# Technical Journal

**Audio switches on steering wheel, no function**REF NO:  
**TJ 32033.5.0**ISSUING DEPARTMENT:  
**Technical Service**CAR MARKET:  
**United States and Canada**PARTNER:  
**3 US 7510 Volvo Car USA**ISSUE DATE:  
**2020-01-08**STATUS DATE:  
**2020-01-14**FUNC GROUP:  
**6414**FUNC DESC:  
**Steering wheel, control buttons**

**TJ-32033 SWS**

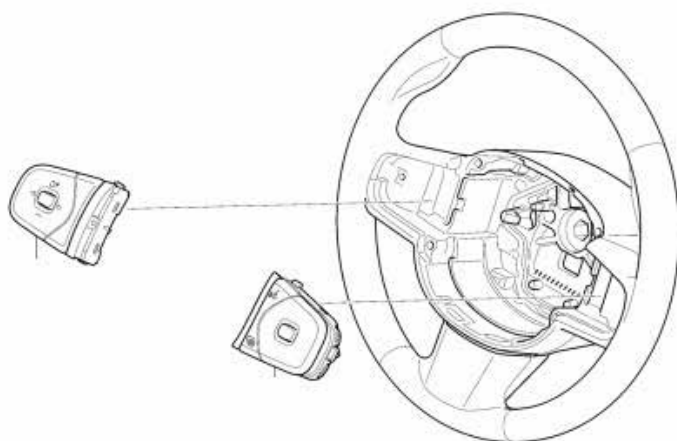
New improved steering wheel switches were introduced week 46, 2019 and come as a complete assembly including both switches and wire harness, see attached picture [TJ 32033 SWSM.JPG](#)  
The new steering wheel switch assembly supersedes the old steering wheel switches.

PN **32266342** Charcoal (Variant code: RU05)

PN **32266343** Crystal Look (Variant code: RU02 or RU06 or RU08 or RU09)
